# UNITED STATES PATENT AND TRADEMARK OFFICE

APPLICATION NO.	FILING DATE	FIRST NAMED INVENTOR	ATTORNEY DOCKET NO.	CONFIRMATION NO.
10/004,803	12/07/2001	Norihide Ooyama	011659	7776
38834	7590	02/23/2005	EXAMINER	
WESTERMAN, HATTORI, DANIELS & ADRIAN, LLP 1250 CONNECTICUT AVENUE, NW SUITE 700 WASHINGTON, DC 20036			ALEJANDRO, RAYMOND	
			ART UNIT	PAPER NUMBER
			1745

**Office Action Summary**

**FIG. 1**

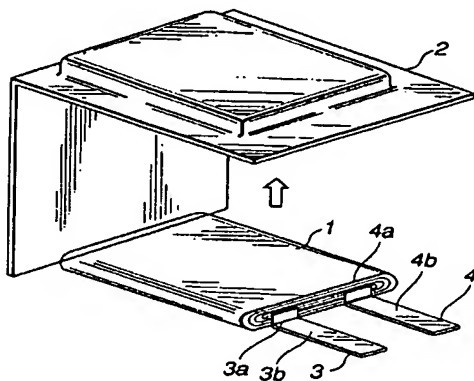
Figures 1-2 below illustrate structures of the pre-sealed and sealed solid electrolyte cell, respectively.

The EP'959 reference teaches that each elongated positive and negative electrodes is constituted by a current collector and a layer of an active material formed thereon (claim 1/page 9, lines 14-24). Further, the EP'959 discloses that the negative and positive terminals are comprised of a current collector 11a and 12a, on each side of which is formed a layer of an active material for the negative and positive terminals 11b and 12b. These layers 11b and 12b are partially removed to expose the current collectors 11a and 12a and the negative terminal leads 13

and 14 are mounted on the exposed portion of the current collectors 11a and 12a (SECTIONS 0023-0024). Thus, it is understood that active material layers are formed on the surfaces of the curved portions positioned on outermost periphery of each positive and negative electrode because active material layers are only removed at the current collector site where the terminal leads are mounted.

**FIG.8**

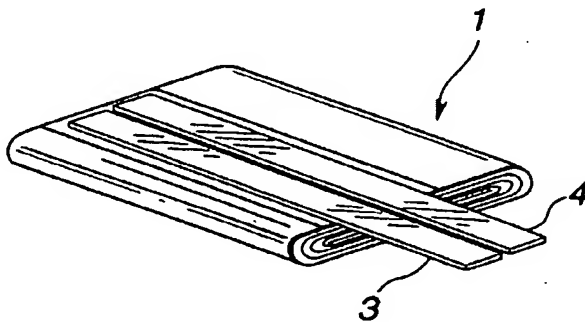
It is further disclosed that the wound assembly is flat-shaped (claim 2/page 9, line 29). Figure 8 shows an unit cell having a terminal lead and a positive terminal lead arranged outside of the winding member. *From Figure 8 below it is apparent that the positive and negative electrode are wound-up by having plane portions and curved portions and having a band shape identical to the instant claims.*

Comparative Example 2 and Figure 8 above show both the negative terminal lead 3 of the negative terminal and the positive terminal lead 4 of the positive terminal placed on the outer side of the winding electrode structure. It is disclosed that the resulting wound assembly is

**FIG. 2**

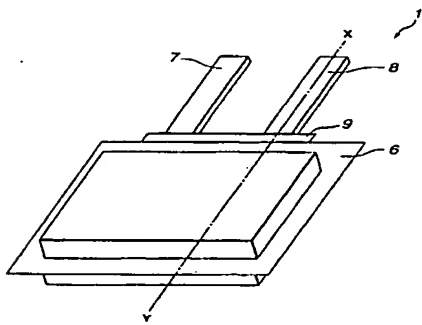
The EP'611 discloses that as shown on Figures 2 and 4, the positive electrode lead 7 and the negative electrode lead 8 are sandwiched by the sealing portion in which is the periphery of the casing film. Moreover, a resin film 9 is disposed in each of the portions in which the positive-electrode lead 7 and the negative electrode lead 8 are brought into contact with the casing film 6 (SECTION 0022, particularly, page 4, lines 14-16).

Further, as is apparent from the Figures 2 and 4 above, the battery element is accommodated in a recessed portion of the casing film, and the electrode leads are placed on its plane portion and the cell is sealed.
